Design Change Notification

To: Sanyo Denki America Cooling DistributorsProduct: Centrifugal FanModel: 9TGA48P0G001, 9TGA24P0H001SANYO DENKI CO., LTD.
Design Dept., Cooling Systems Div.

o Detail of the changing

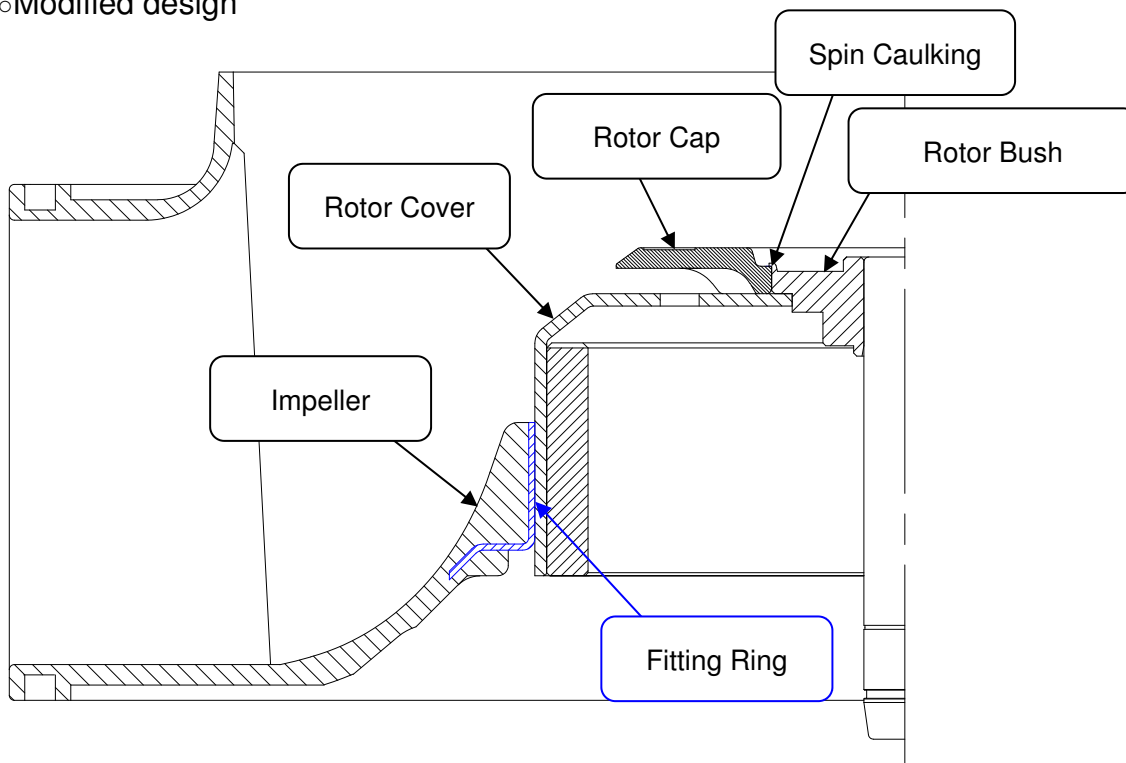
No	Contents	Existence	Modification	Description
1	Design changing of the rotor.	Please refer A0041785 Appendix.	Please refer A0041785 Appendix.	<p>We would like to change the rotor design to improve the commonality of parts with other models.</p> <p>There is no influence on its performance and quality by the change.</p> <p>Implementation Date: From the production in October or November 2018.</p> <p>Please note that the schedule might be changed due to initial material availability.</p>

- Changing the adhesion between impeller and rotor cover from adhesion, to press fitting by a fitting ring.
- Changing the adhesion between rotor cap and rotor cover thermal caulking by the rotor cap, to spin caulking by a rotor bush.
- The design between existing impeller and modified impeller are same without fixing part of impeller and rotor cover.
